SUBJECT: NuScale Power, LLC Submittal of Changes to Part 2 Tier 2 Final Safety Analysis Report, Chapters 1, 4 and 15 and Part 4, Technical Specifications

Enclosure: Changes to NuScale Part 2 Tier 2 Final Safety Analysis Report Chapters 1, 4 and 15
and Part 4, Technical Specifications

Figure 4.4-1: Critical Heat Flux Ratio Limits and Thermal Margins

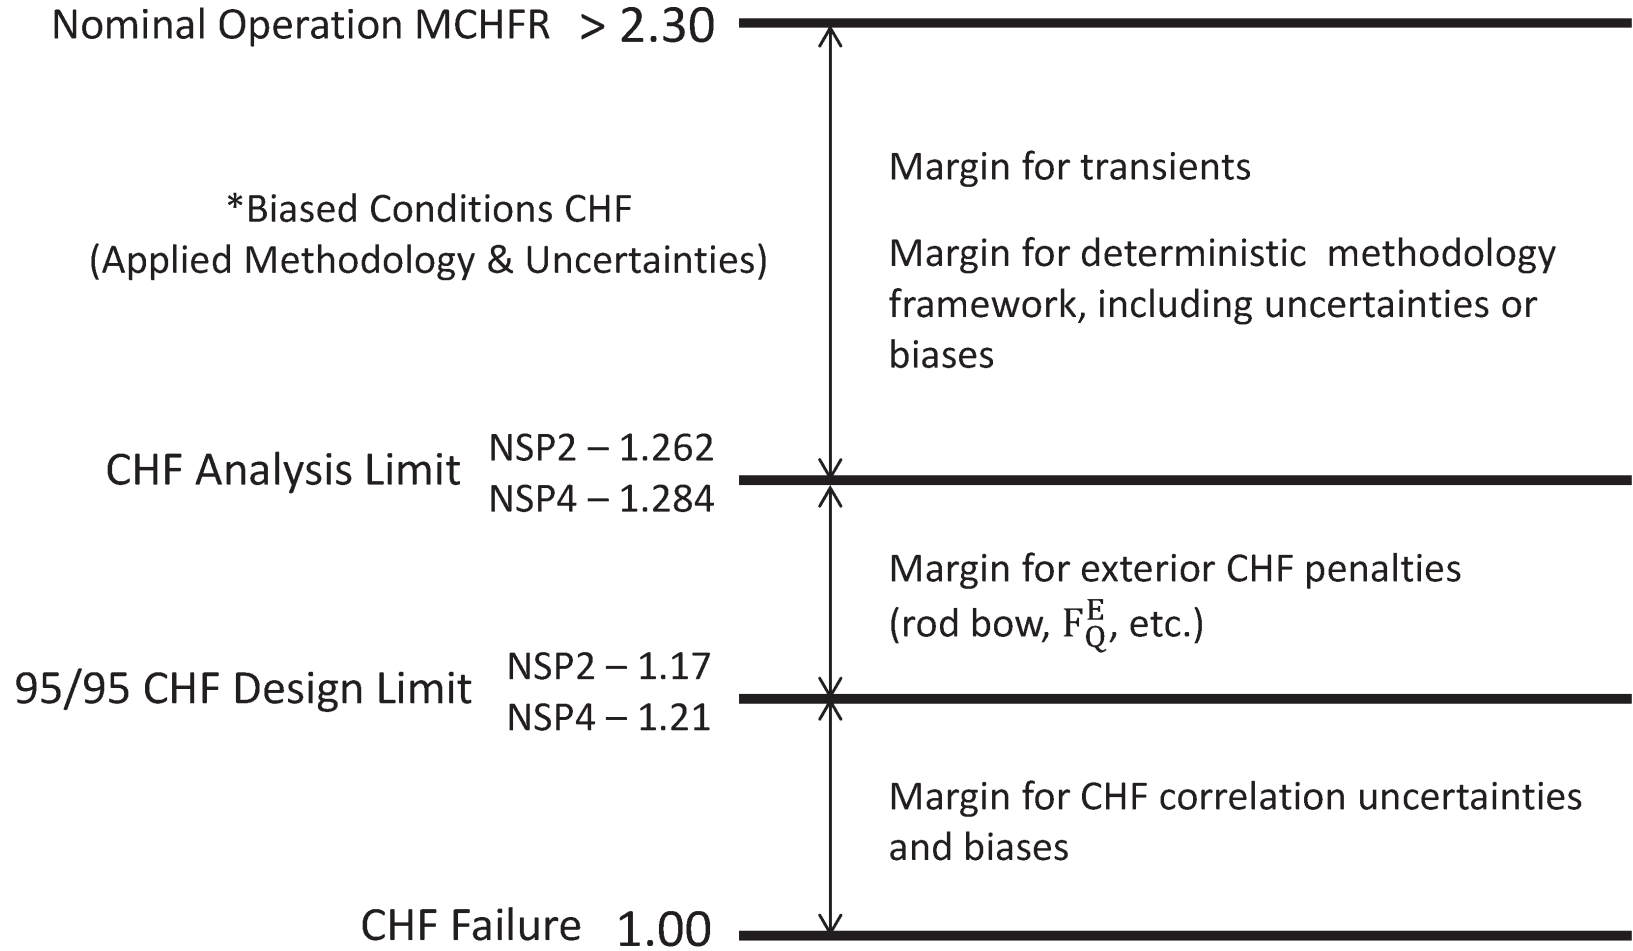
Uncertainties or biases are incorporated into the subchannel methodology to provide conservatism. These uncertainties establish the design limit for the CHF correlation as shown in Figure 4.4-1. The derivation of the penalties or conservative bias are discussed in Reference 4.4-3. Uncertainties in the CHF correlation, analytical methods, operating conditions, physical inputs, core inlet flow distribution, and core exit pressure are considered in the subchannel analysis.

Figure 15.4-36: Critical Heat Flux Ratio
(15.4.3 Control Rod Misoperation, Control Rod Assembly drop)

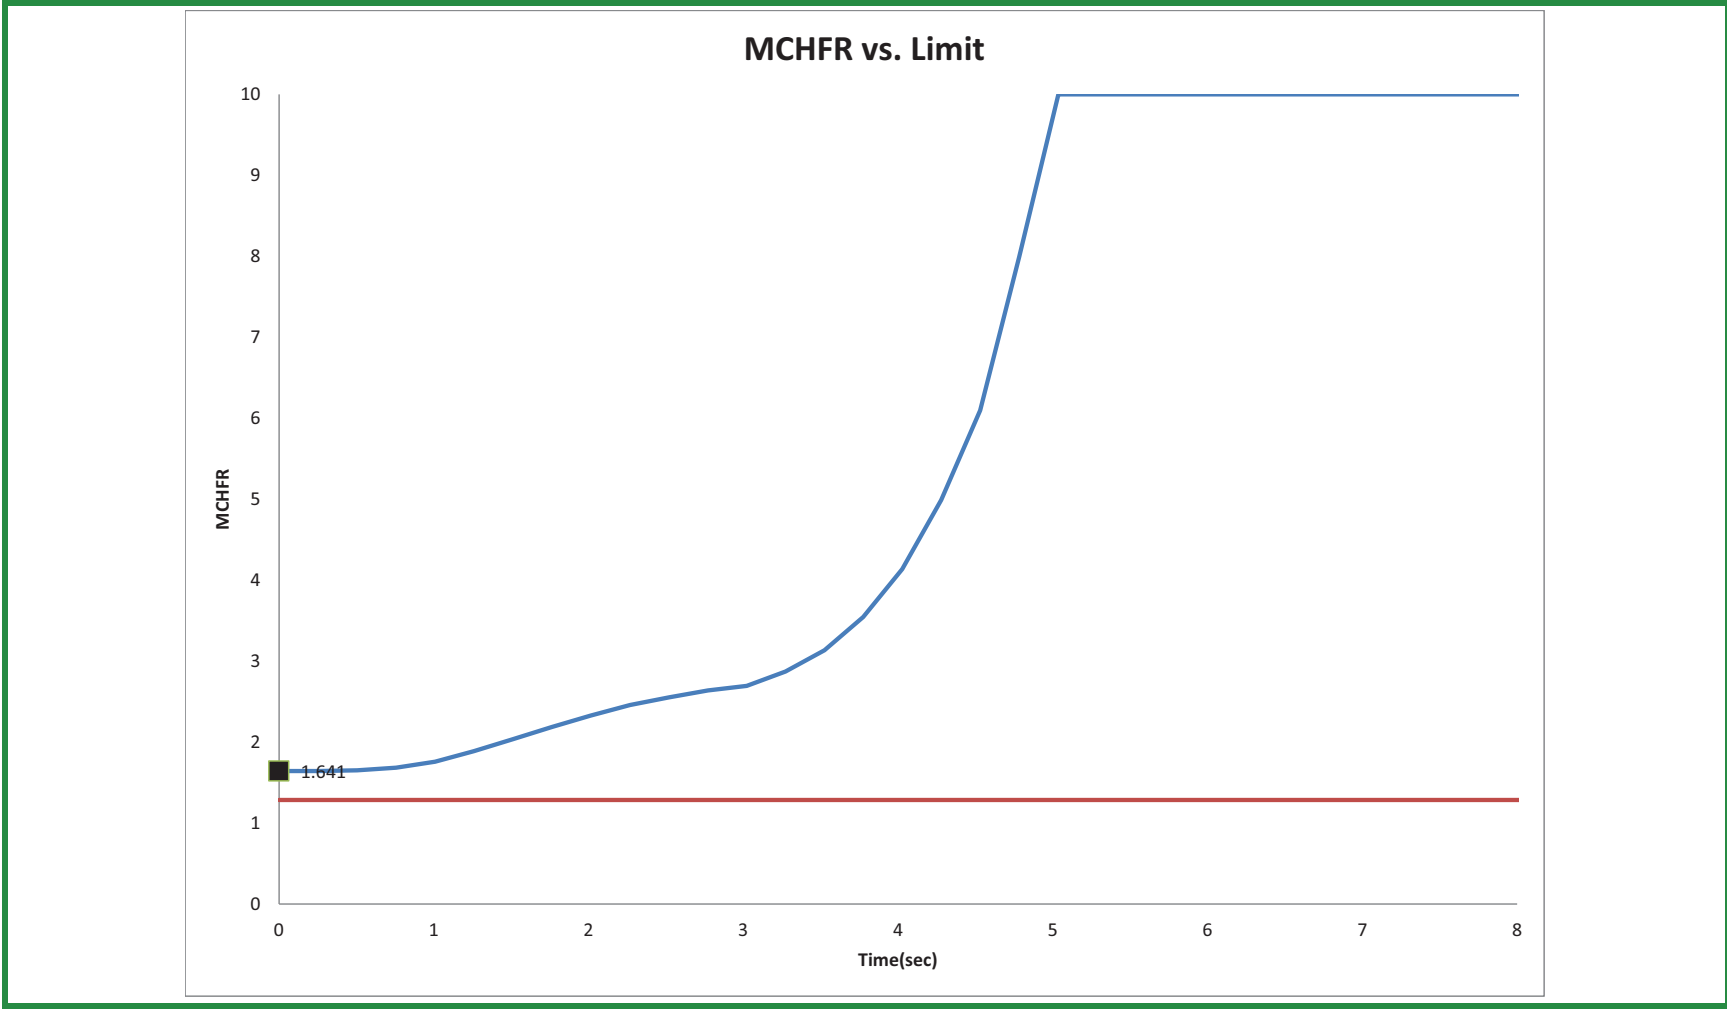
Exceeding the RPV design pressure is not a concern for the limiting rod drop case, which is demonstrated in the RCS pressure plot. The MCHFR for the limiting case, [Figure 15.4-36](#), remains above the design limit. The LHGR calculated for the limiting rod drop case is below the limits for fuel melting and cladding strain.

Figure 15.4-37: **CHFR (15.4.8 Rod Ejection Accident)**

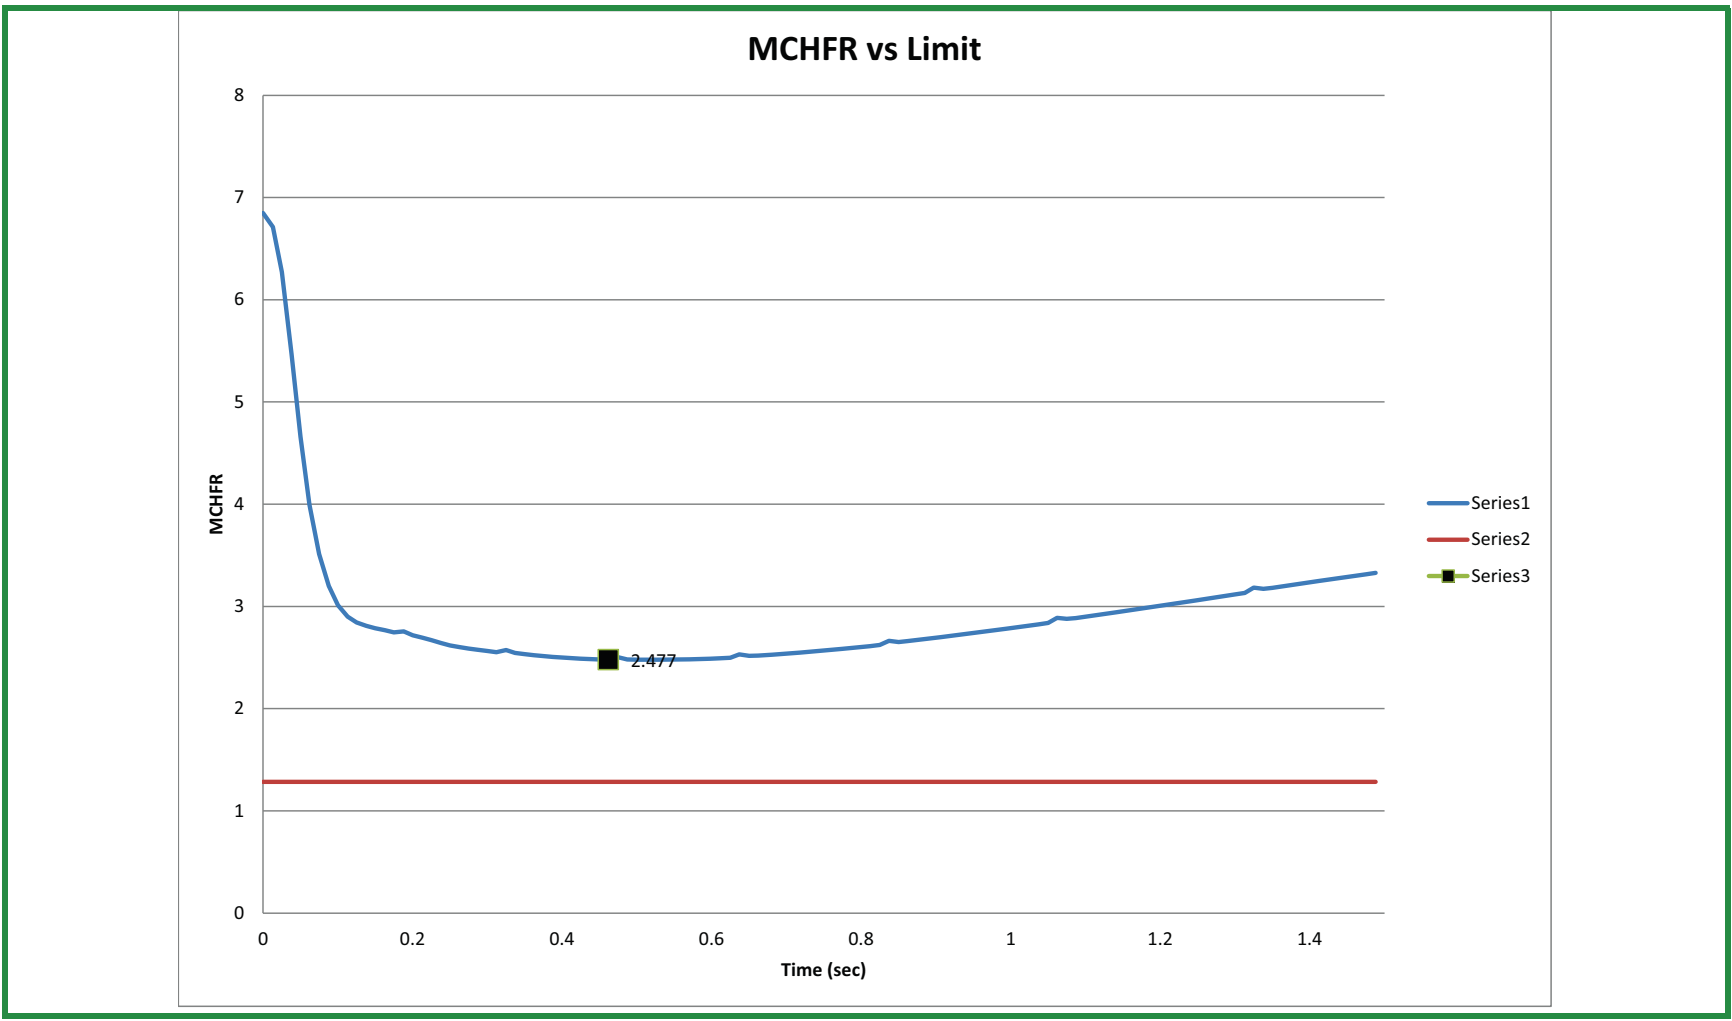
The subchannel analysis evaluates a spectrum of REA conditions that are provided by the S3K and NRELAP5 analyses. The REA case that results in the limiting MCHFR is an REA that occurs at an initial power of 70% at EOC. The limiting MCHFR ~~is 1.47,~~ [which](#) is above the design limit as demonstrated in ~~Figure 15.4-32~~ [Figure 15.4-37](#).
